**Plymouth South High School**  
Plymouth, MA  
Ai3 Project # - 1308.00

**Addendum #2**

June 11, 2015

DRAWN BY:	AJE	<b>SKL-002</b>
SCALE:	N/A	
JOB NO:	1308.00	
DATE:	06/11/2015	
REF DWG:	L33

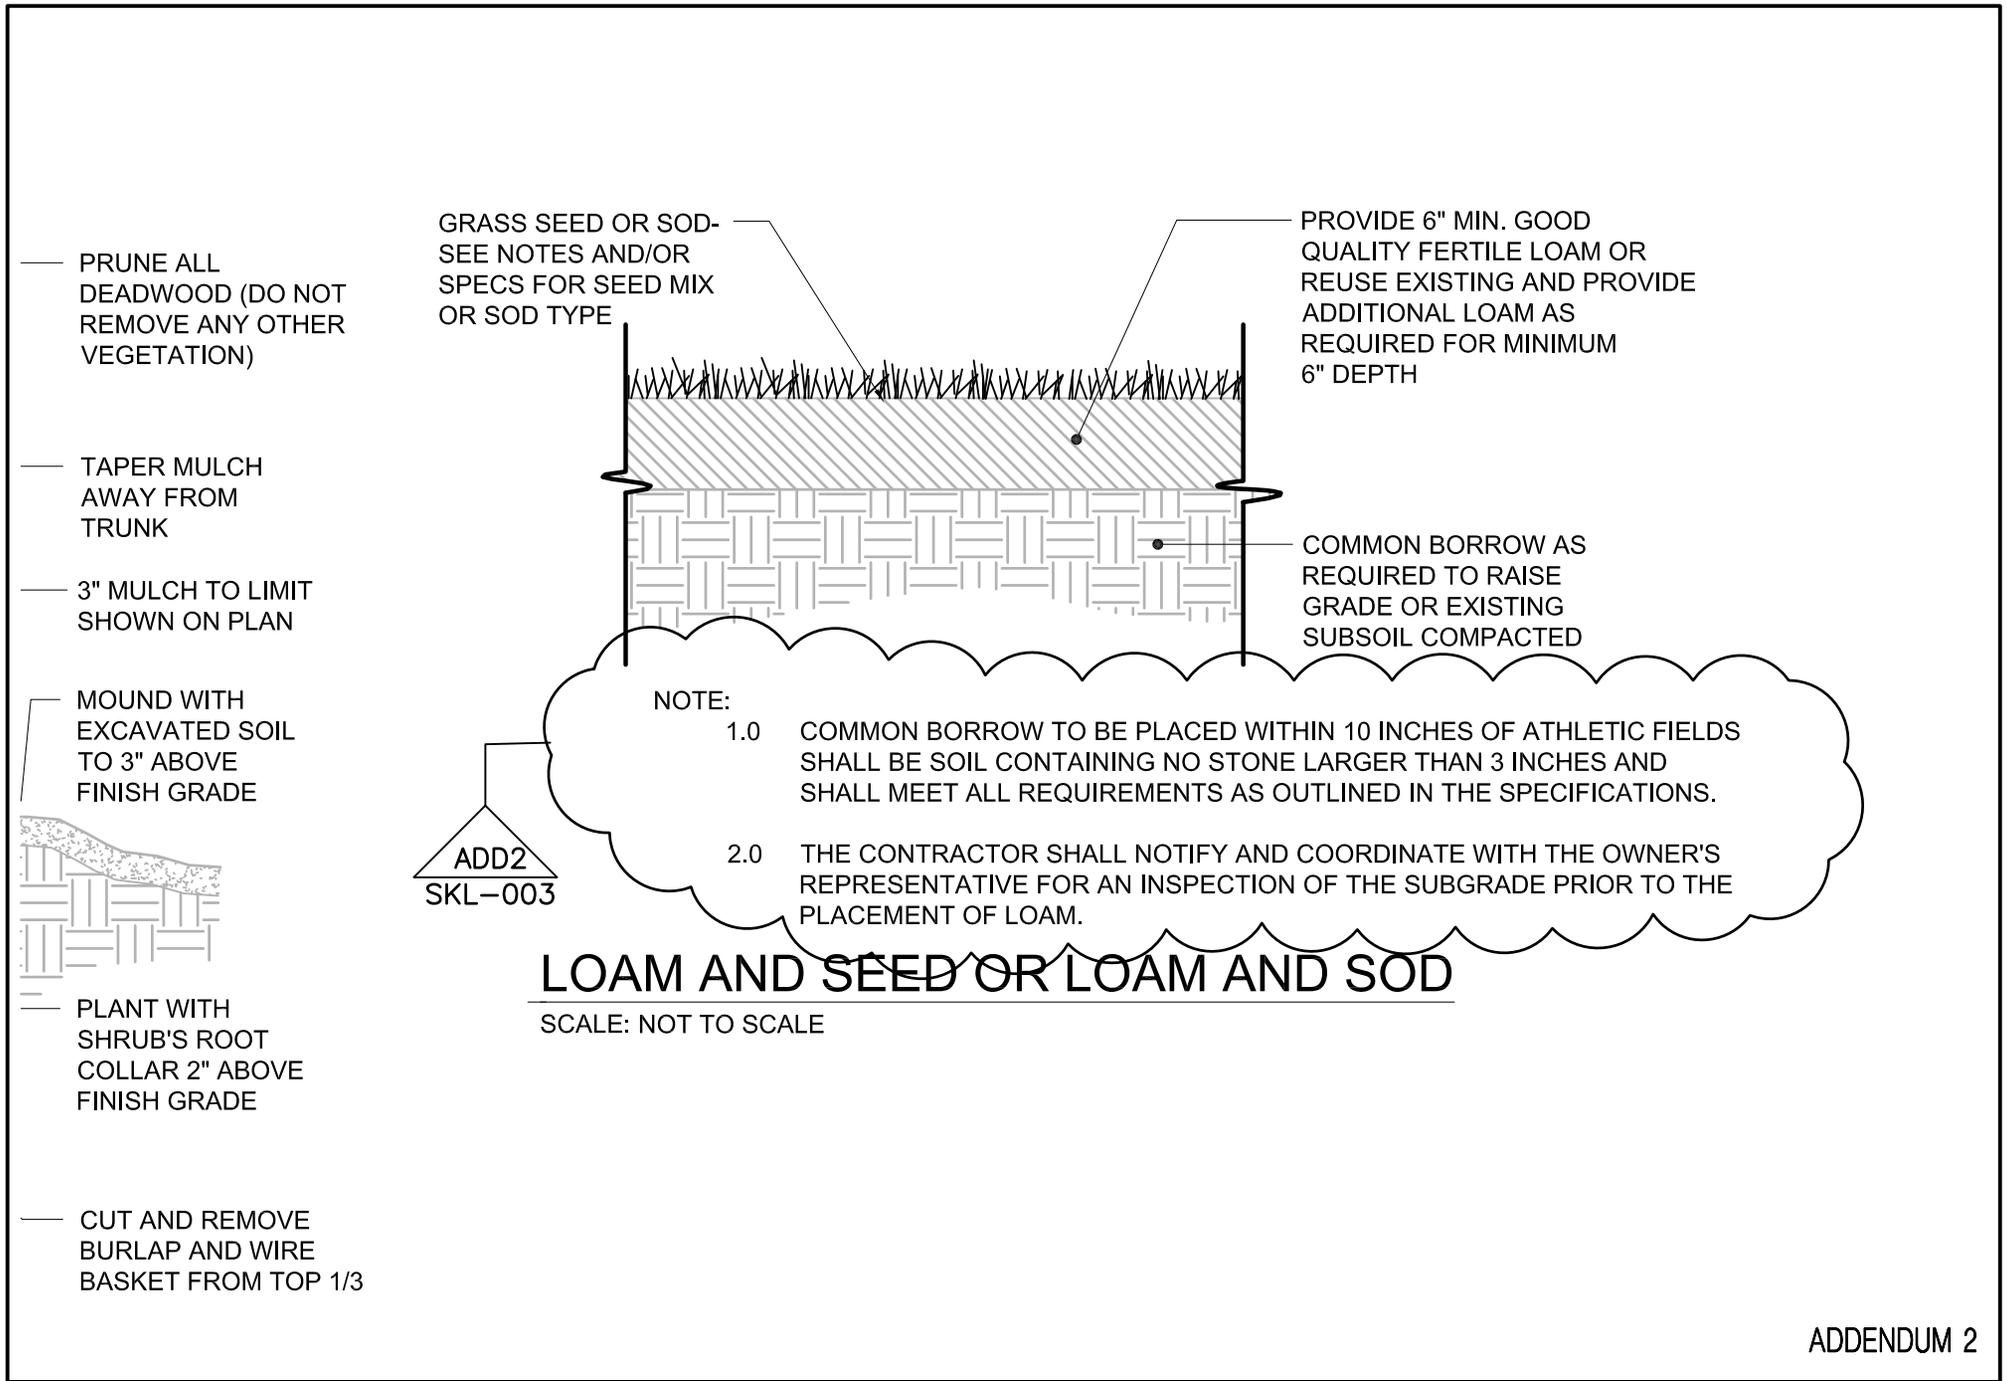
2.0 THE CONTRACTOR SHALL NOTIFY AND COORDINATE WITH THE OWNER’S REPRESENTATIVE FOR AN INSPECTION OF THE SUBGRADE PRIOR TO THE PLACEMENT OF LOAM.”
- ADD 2-0154 Drawing L3.3 – Landscape Details Plan No. 4  
Detail 1 / Track Layout:  
Alternate Tag – REMOVE: “ALTERNATE #2” and REPLACE with “ALTERNATE #3”  
Alternate Tag – REMOVE “ALTERNATE 1” and REPLACE with “ALTERNATE #3”

DRAWN BY:	AJE	<b>SKL-003</b>
SCALE:	N/A	
JOB NO:	1308.00	
DATE:	06/11/2015	
REF DWG:	L15

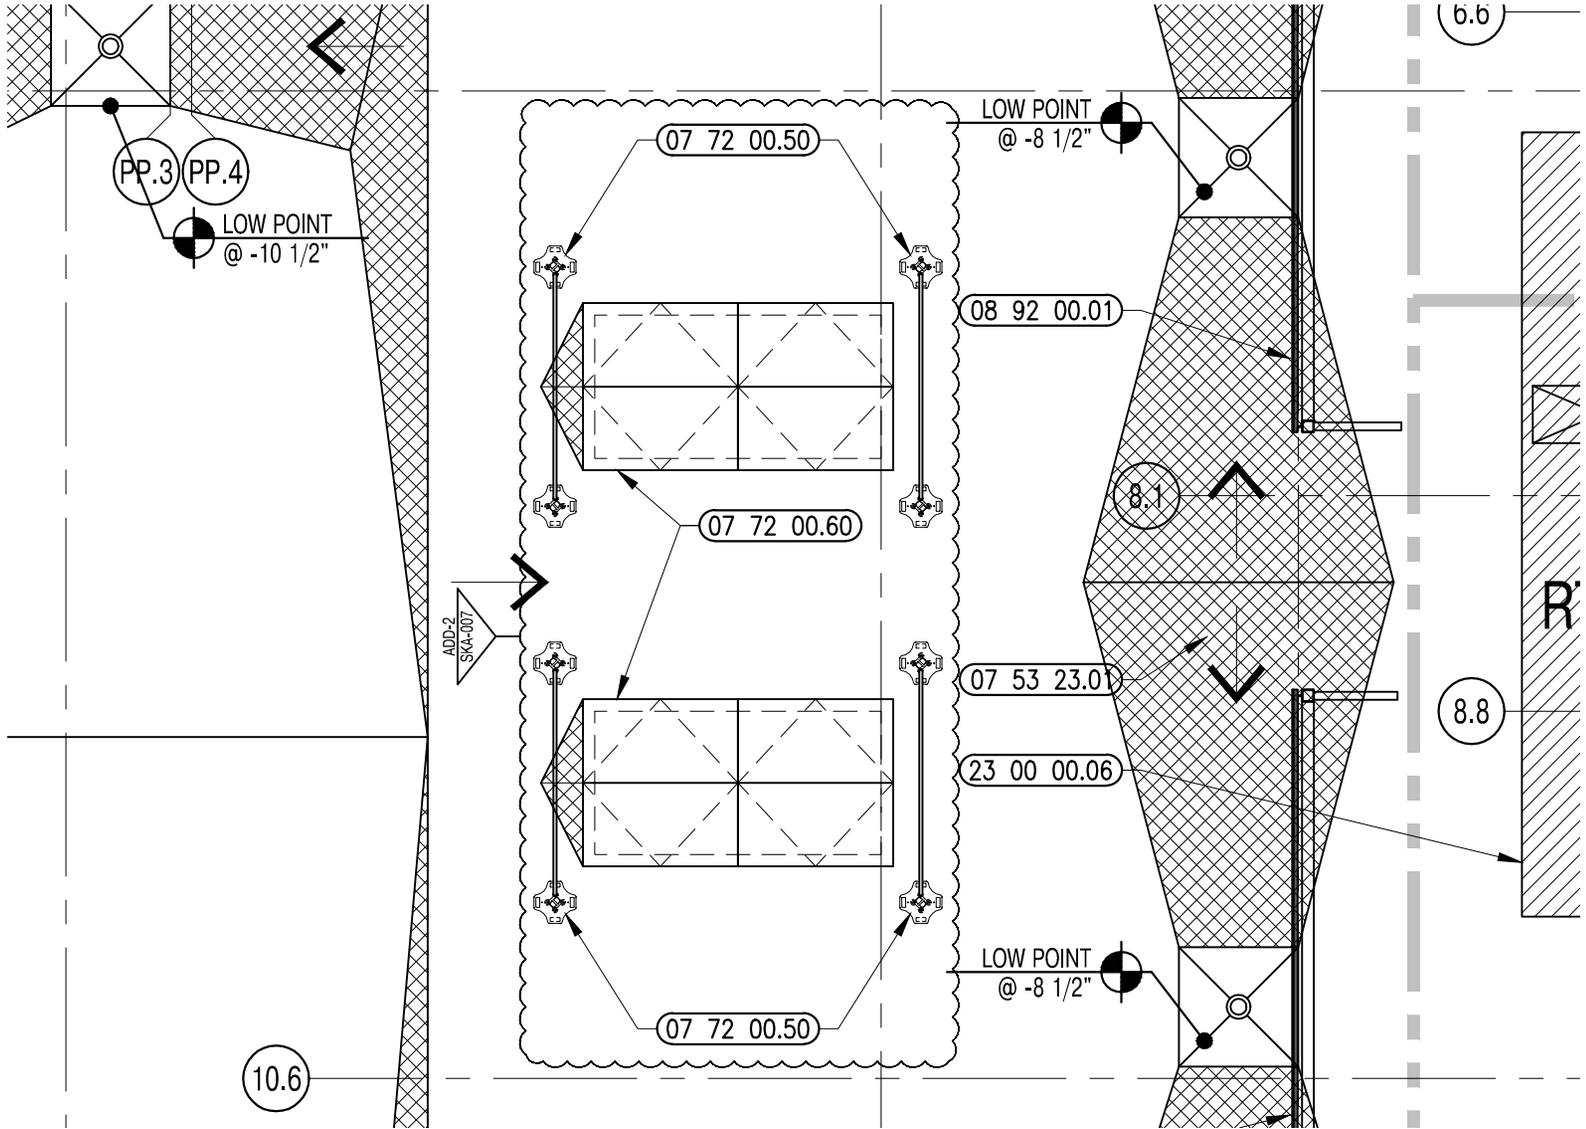
- ADD 2-0153 Drawing L1.5 – Planting Details  
Detail – Loam and Seed or Loam and Sod  
ADD:  
“NOTE:  
1.0 COMMON BORROW TO BE PLACED WITHIN 10 INCHES OF ATHLETIC FIELDS SHALL BE SOIL CONTAINING NO STONE LARGER THAN 3 INCHES AND SHALL MEET ALL REQUIREMENTS AS OUTLINED IN THE SPECIFICATIONS.

SKA-025
REF DWG: A11.21

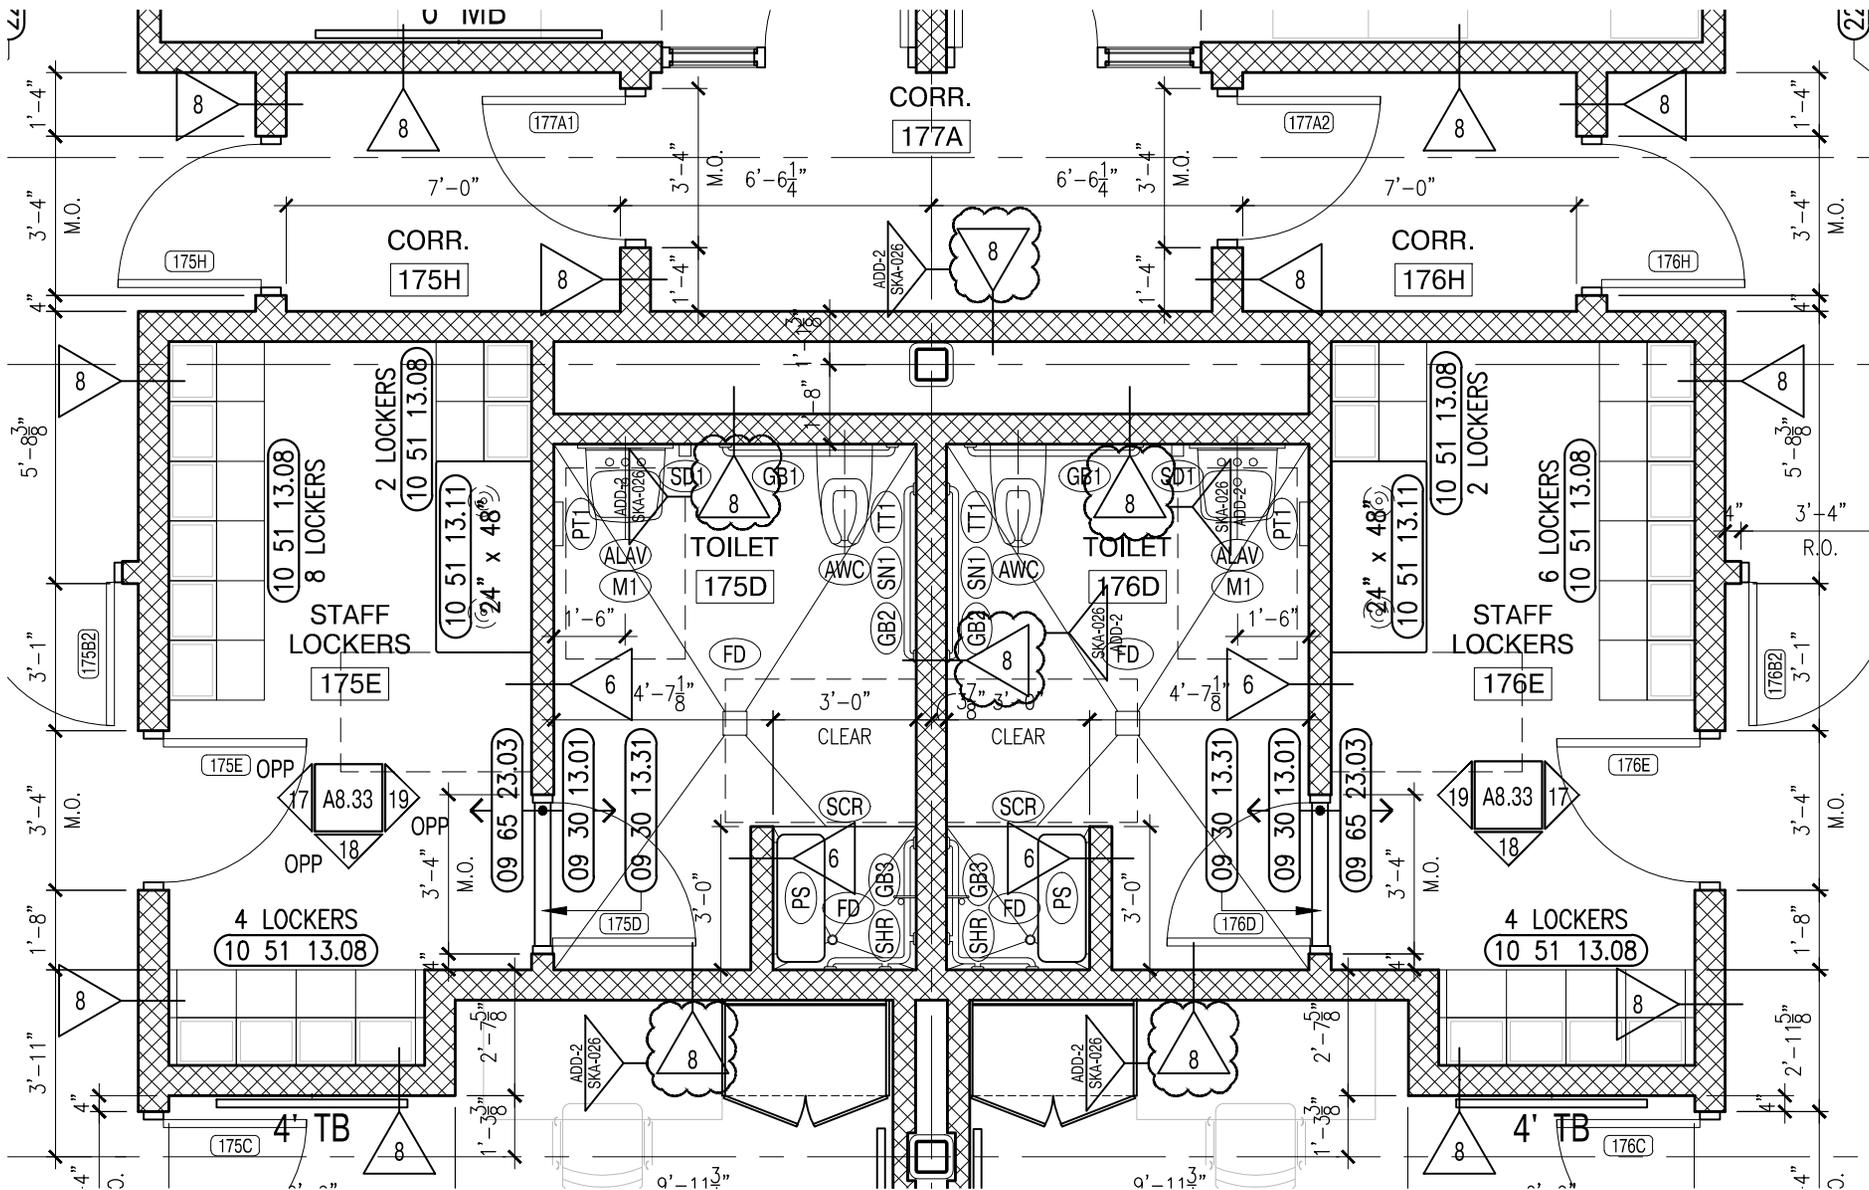
Detail 1 / Storage/Support/Restroom Facility Plan; DELETE text note "FLUID ATHLETIC FLOOR" located in room "Team Room / Support – F101"

Detail 2 / Storage/Support/Restroom Facility RCP; DELETE text note "FLUID ATHLETIC FLOOR" located in room "Team Room / Support – F101"

DRAWN BY:	JPT	<b>SKA-026</b> REF DWG: A8.32
SCALE:	1/4" = 1'-0"	
JOB NO:	1308.00	
DATE:	6/11/2015

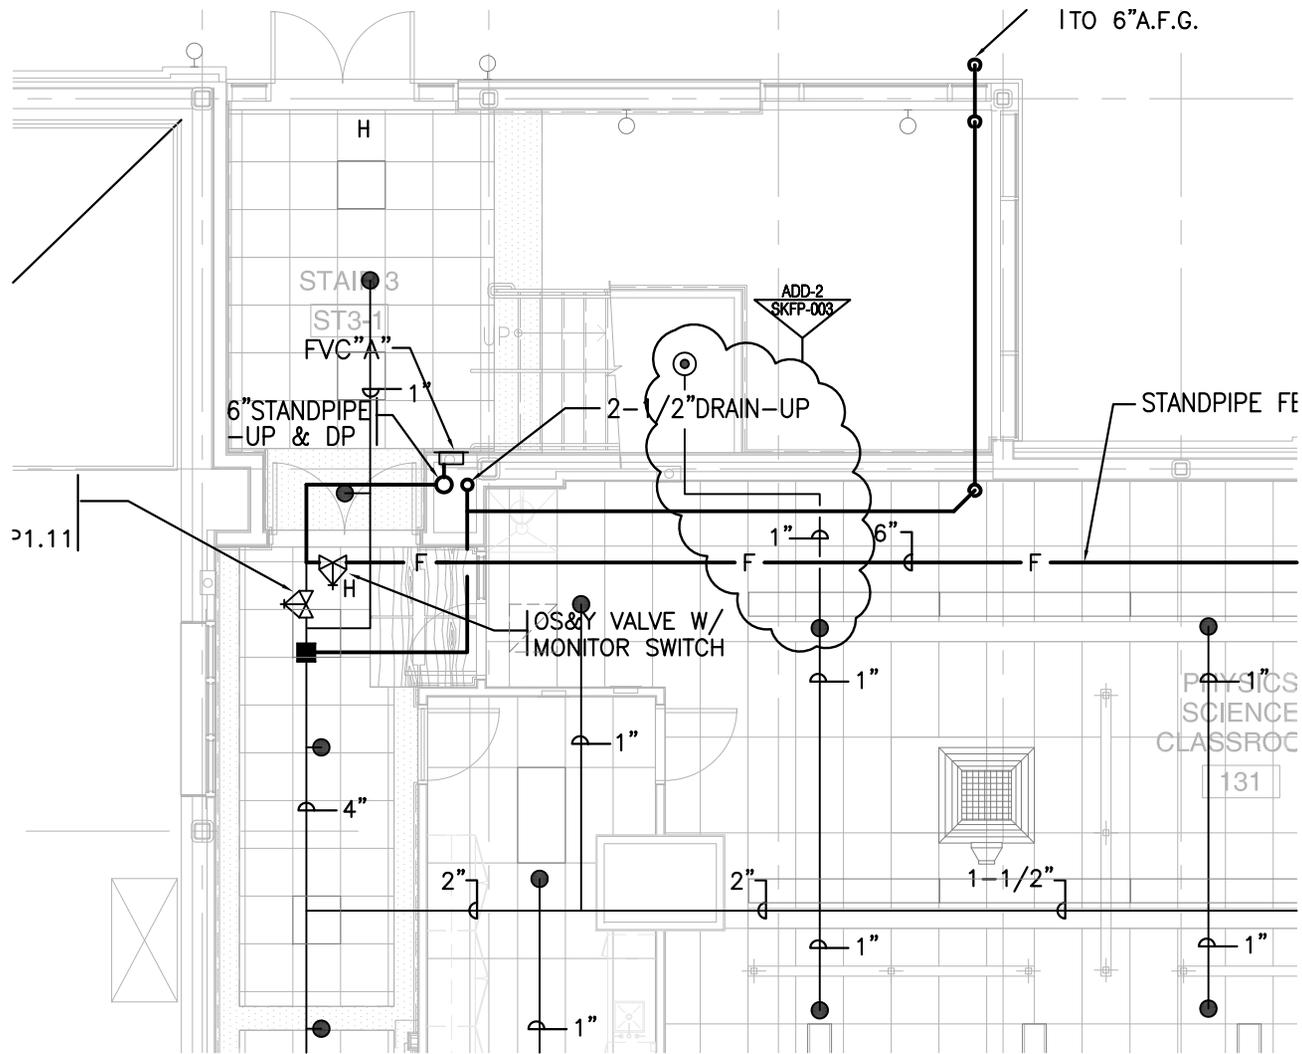
- ADD 2-0177     Drawing A8.32 – Enlarged Locker Room Plans  
The CMU wall located on gridline UU is currently tagged as type “6”. REMOVE this tag and REPLACE with wall type tag “8”

<b>SKFP-003</b>
REF DWG: FP1.12

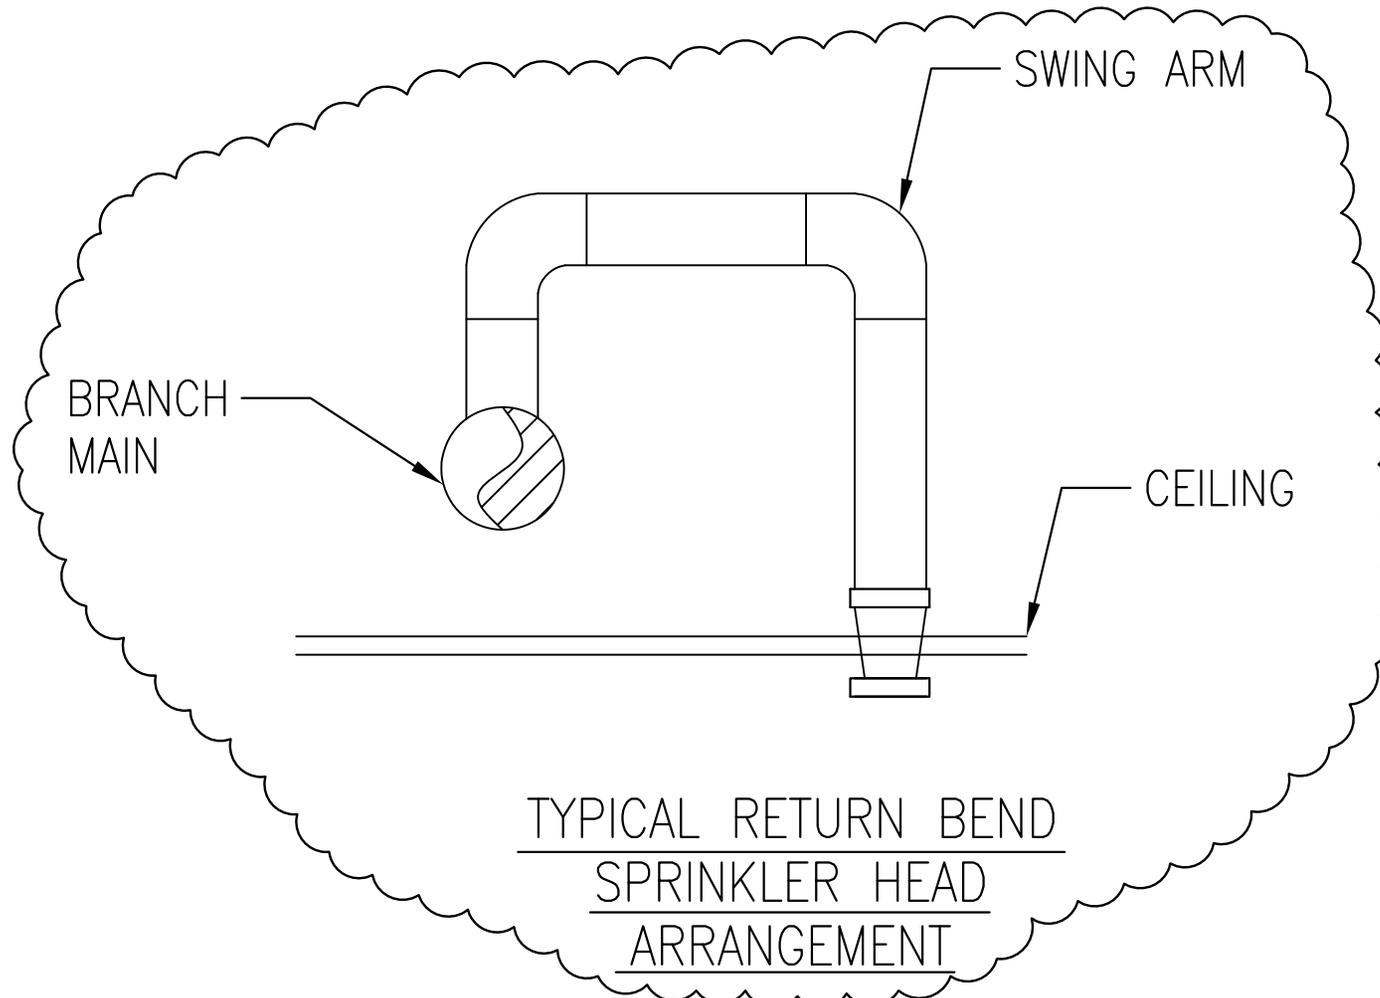
- ADD 2-0208     Drawing FP1.11 – First Floor Plan Zone 1  
                  ADD a sprinkler head under Stair 2
- ADD 2-0209     Drawing FP1.12 – First Floor Plan Zone 2  
                  ADD a sprinkler head under Stair 3

<b>SKFP-004</b>
REF DWG: FP1.13

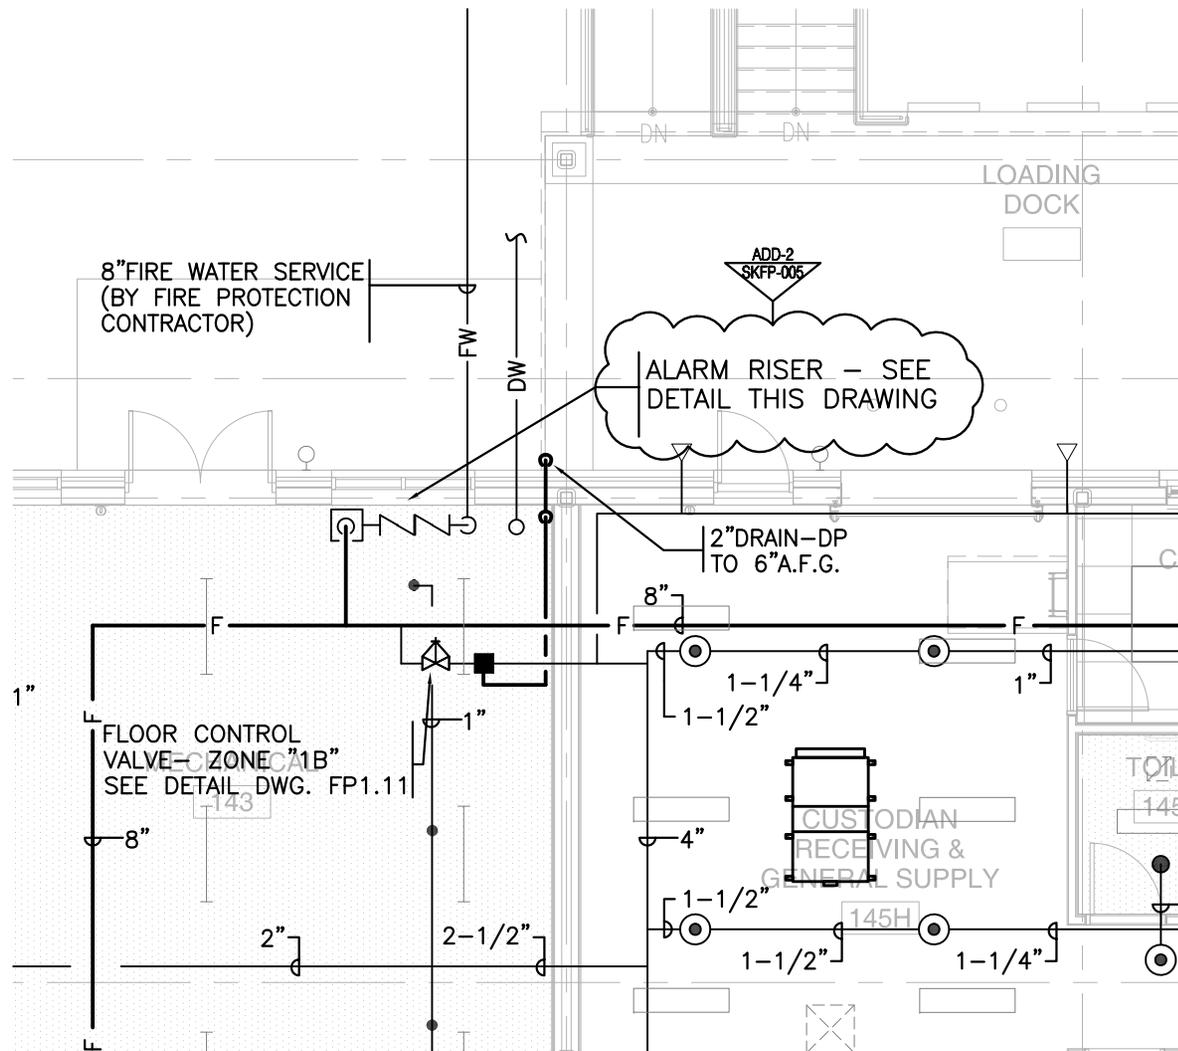
- ADD 2-0210     Drawing FP1.13 – First Floor Plan Zone 3  
                  REMOVE backflow preventer & from note at Loading Dock  
                  Change Typical Sprinkler Head Installation to Typical Return Bend Sprinkler Head Installation
